UNITED STATES PATENT AND TRADEMARK OFFICE

10/003,058	11/02/2001	Saul R. Dooley	GB 000151	4908
------------	------------	----------------	-----------	------

Office Action Summary

DETAILED ACTION

FIG. 1

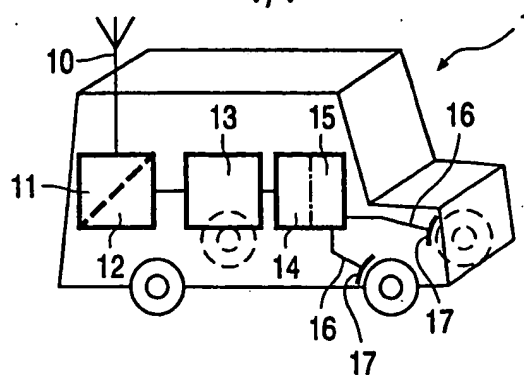
2. The drawings are objected to because there are no labels for each blocks in figures 1 and 2 and blocks 11, 12, 13, 14, 15, and in figure 1, 18 and 19 in figure 2, and 24 in figure 3. These blocks need to have descriptive labels under 37 CFR 1.84(n) and 1.84(o).
